**ASHLAND PLANNING DEPARTMENT
PRE-APPLICATION CONFERENCE
COMMENT SHEET**
May 7, 2025

SITE: Scenic Drive Tax Lot 7302
APPLICANT: Rogue Planning &
Development Services
REQUEST: Land Partition

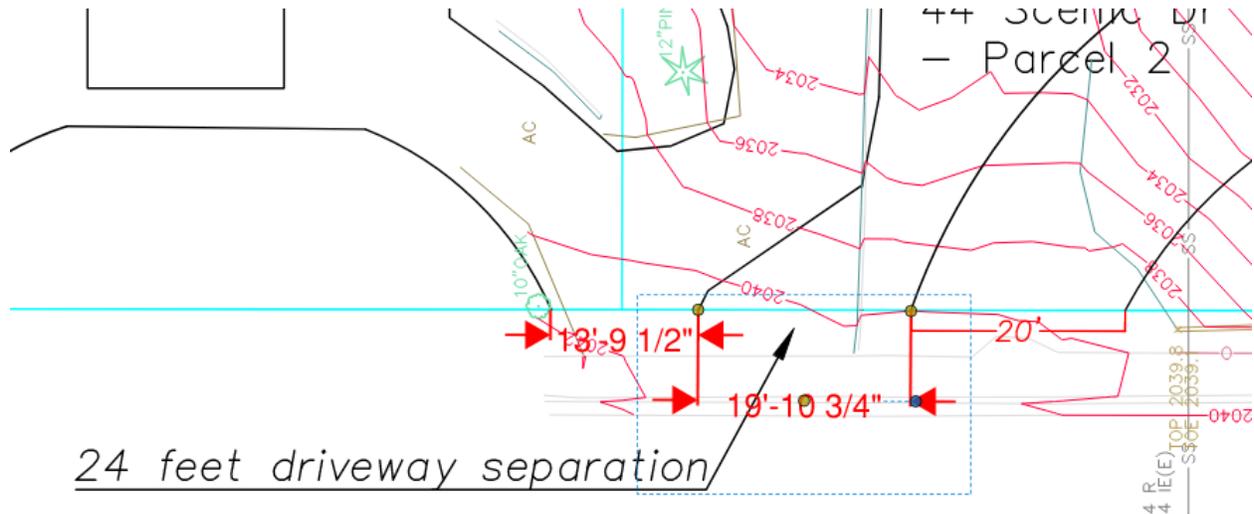
The existing driveway is far wider than the maximum allowed and will need to be reduced in width. Based on overhead images we believe that the existing driveway is roughly 30' wide.

The drawing indicates that the driveway is proposed to be roughly 14' wide when it is in fact nearly twice that. Also, it appears that the drawing is not providing the required 24' driveway separation based on the proposed drawings and existing improvements.

1. A driveway for a single-family dwelling or a duplex shall be a minimum of nine feet in width except that driveways over 50 feet in length or serving a flag lot shall meet the width and design requirements of section [18.5.3.060](#). Accessory residential units are exempt from the requirements of this subsection.

D. Except as provided in subsection [18.5.3.060.H](#), below, the flag drive serving a single flag lot shall have a minimum width of 15 feet and contain a 12 foot wide paved driving surface. For drives serving two flag lots, the flag drive shall be 20 feet wide, with a 15 foot wide driving surface to the back of the first lot, and a 12 foot wide driving surface to the rear lot. **Drives shared by adjacent properties shall have a width of 20 feet, with a 15 foot paved driving surface.** Width shall be increased on turns where necessary to ensure fire apparatus remain on a paved surface during travel.
